APPLICATION FOR ERECTION OF BRICK BUILDINGS,

1. State how many buildings to be erected.
2. What is the exact location thereof? (State on what street or avenue; the side thereof, the number of feet from the nearest street or avenue, and the name thereof)
18-100

Application #259 N. B. 1905, is disapproved

259 N. B. B, 190 5.

PLAN - Typical Floors

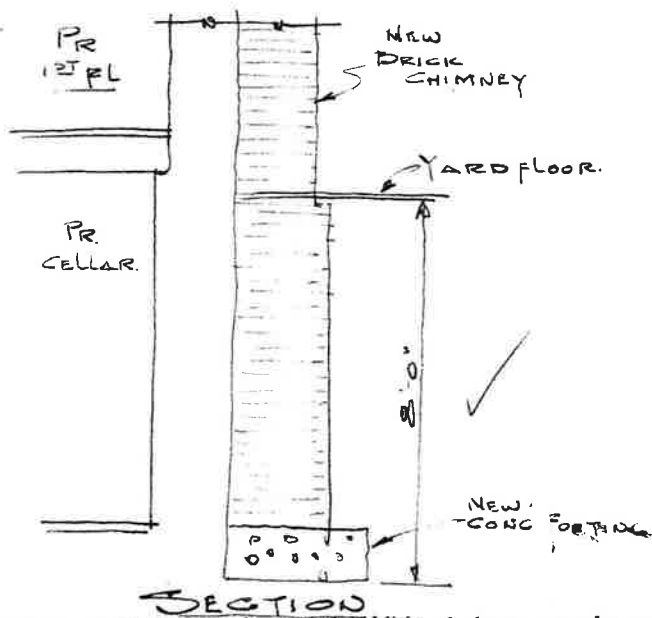
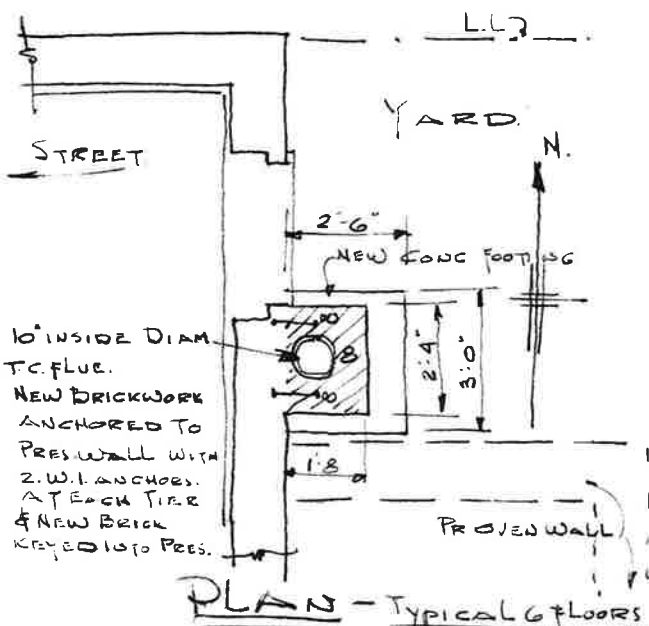
Propose to amend the approved plan for erecting the new chimney at north end of rear yard. Flue to be 10" inside diameter. Overall dimensions of chimney 2'4" x 1'8". Brickwork keyed into present brick wall and to have two (2) Wrought Iron anchors at each tier. Chimney to be set on Concrete Foundation 3'-0" x 2'-6" and 3'-0" below yard floor on solid ground.

PREMISES		DOB NO.
98-100 AVENUE "C"		1696 68
BOROUGH OF MANHATTAN		
DRAWN BY	BLOCK 376	3/4" = 1'-0"
A.J.C	LOT 5	
CHECKED BY	ZONE C2-5	A-2
BN 1169-68 4-22-1968		SHEET 2 OF 2

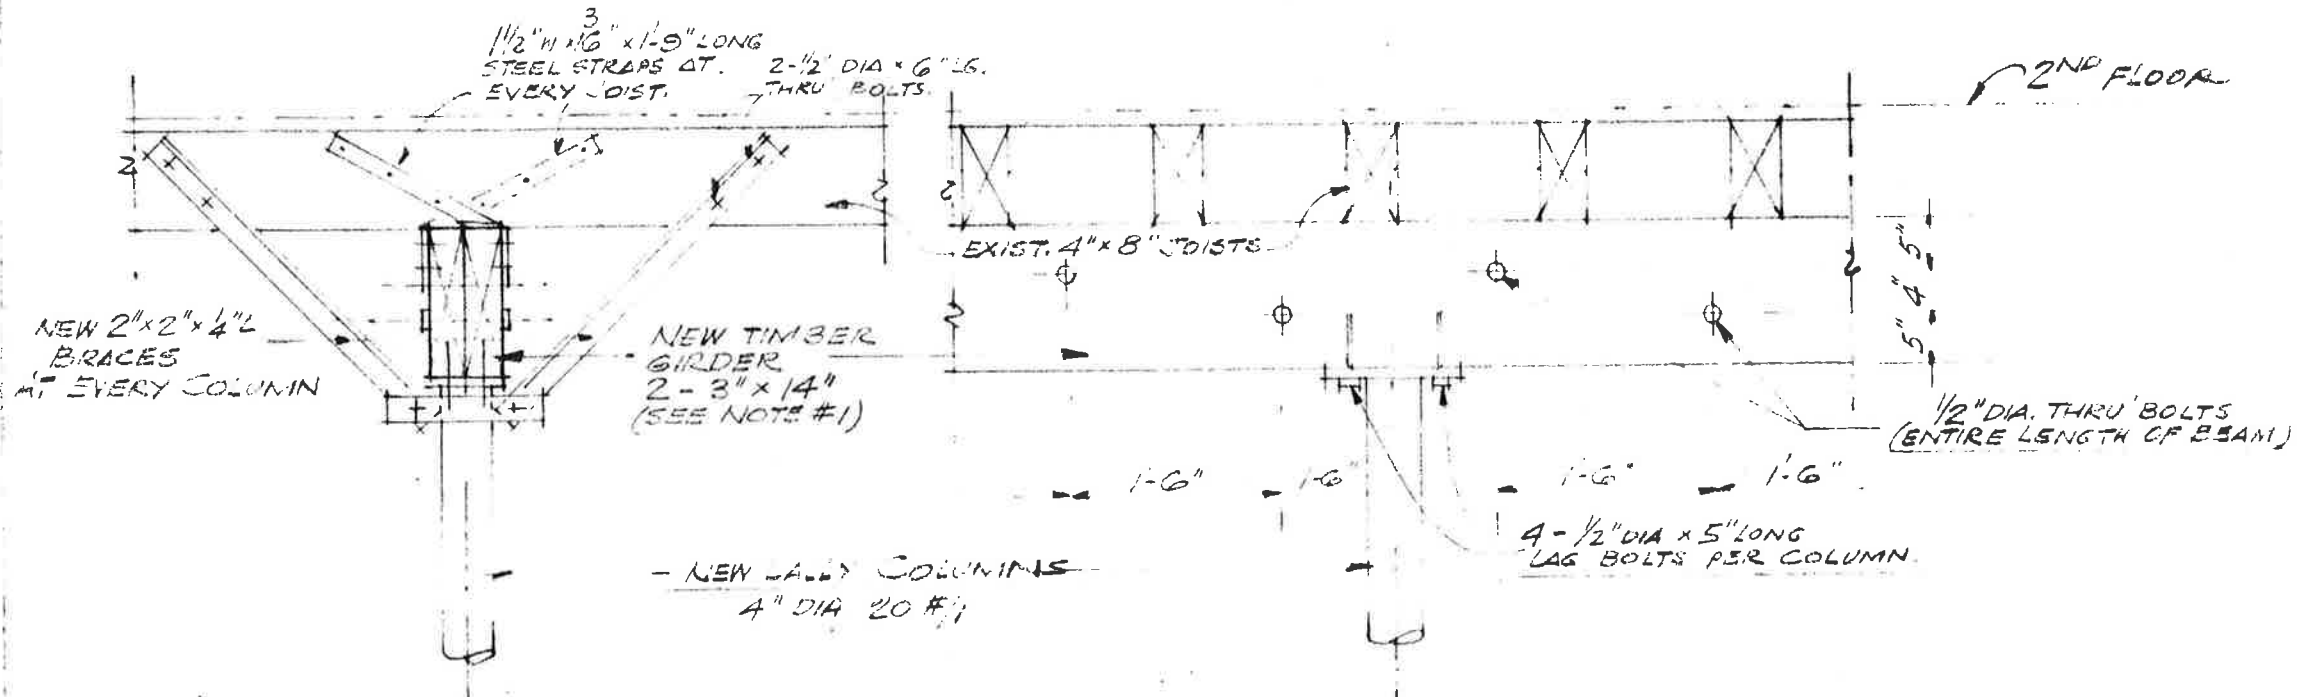
- (1) New timber girder (2- 3" x 14") to be Southern Longleaf Yellow Pine, grade either DENSE STRUCTURAL 65 or MERCHANTABLE STRUCTURAL LONGLEAF with a minimum allowable bending stress of f-1800 p.s.i.
- (2) Timber must be grade marked when delivered to job and must not be notched in any way.
- (3) This plan must be read in conjunction with and forms part of plan A-1 dated 3/20/68 approved heretofore and, except as expressly shown on this plan, all requirements of said plan A-1 shall remain in full force and effect.
